ADDENDUM NO. 1

**PROJECT NO. TMUA-W 25-08 YAHOLA TERMINAL STORAGE
RESERVOIR IMPROVEMENTS**

Yahola Terminal Storage Reservoir Improvements TMUA-W 25-08

ADDENDUM NO. 1, dated April 8, 2026

Photo 1 – showing the existing perimeter road and existing slope walls adjacent to the West Gate Berm Structure. White arrow shows approx. project location.

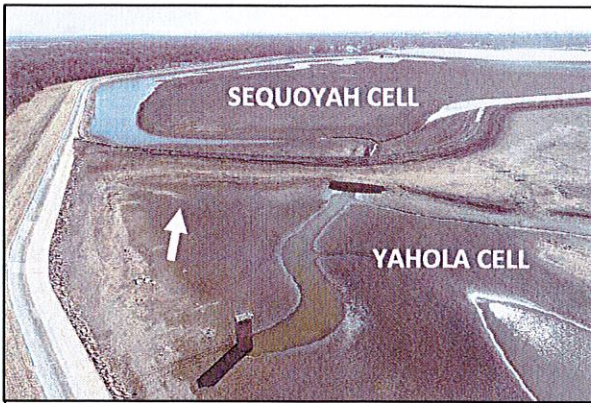
Q14: Can the photographs of the typical east and west submerged beam be provided?

- Response: Yes, see the submerged berms photographs on next sheet of the Addendum.

CONSTRUCTION PLANS FOR YAHOLA TERMINAL STORAGE RESERVOIR IMPROVEMENTS

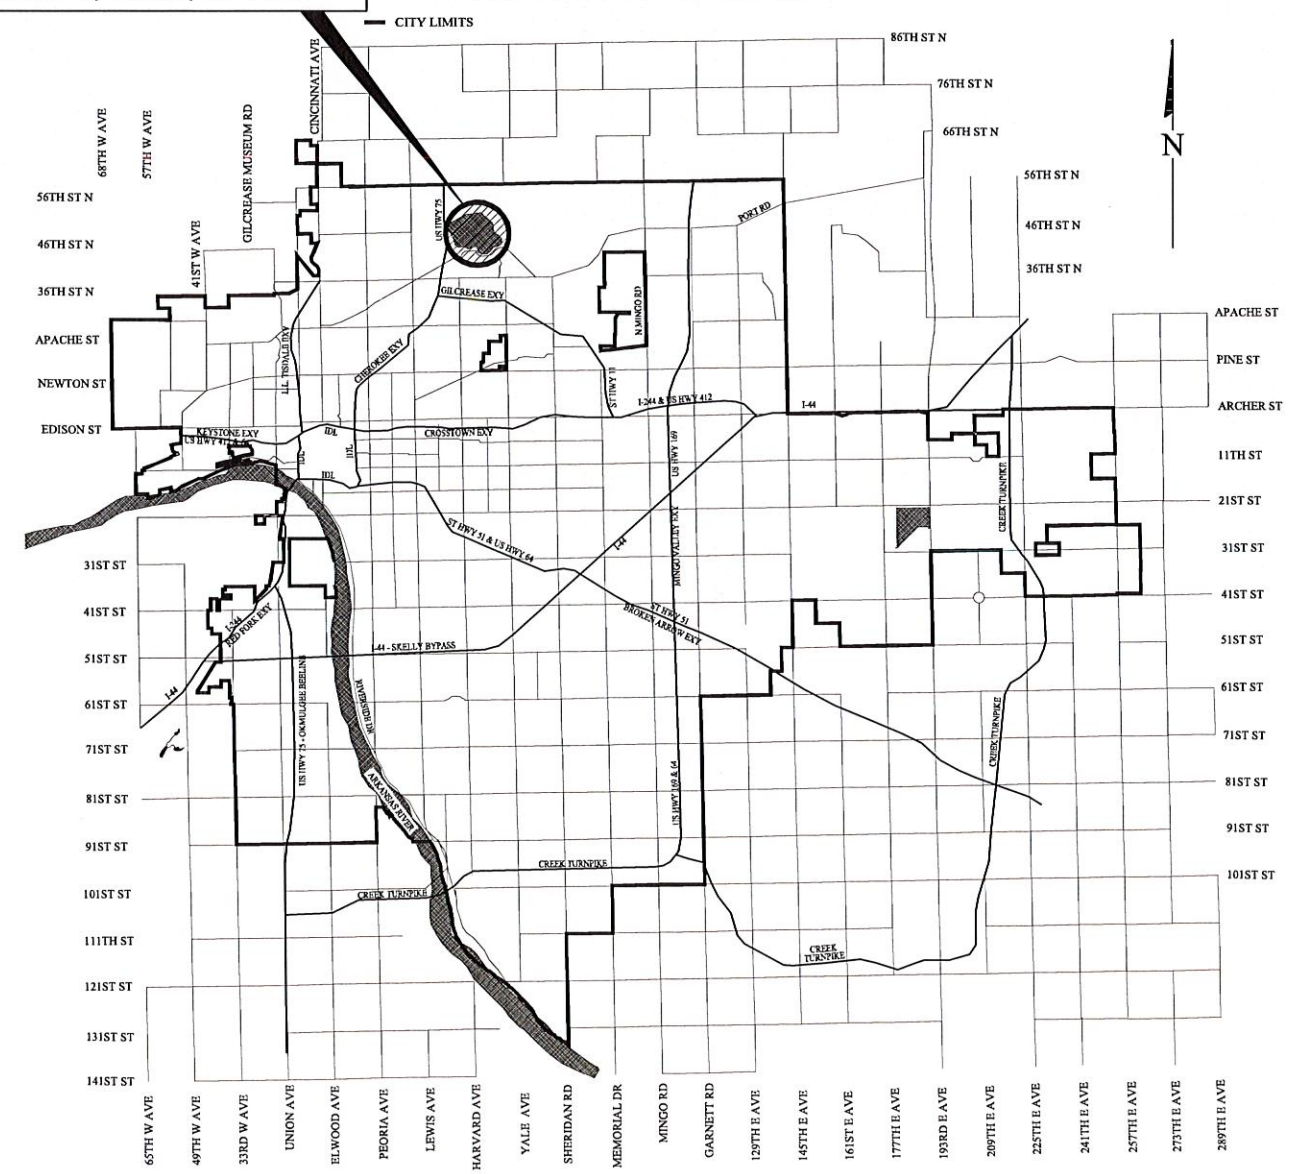
- 1) Sheet 4. Project Scope #1. Change the text "SLUICE GATE" to "SLIDE GATE".
- 2) Sheet 2-55. Below the OKIE811 logo, add the text "SCALES ON THIS SHEET ARE FOR FULL SIZE SHEETS UNLESS NOTED OTHERWISE".

SCALES IN THIS PLAN SET ARE FOR FULL SIZE SHEETS UNLESS NOTED OTHERWISE.
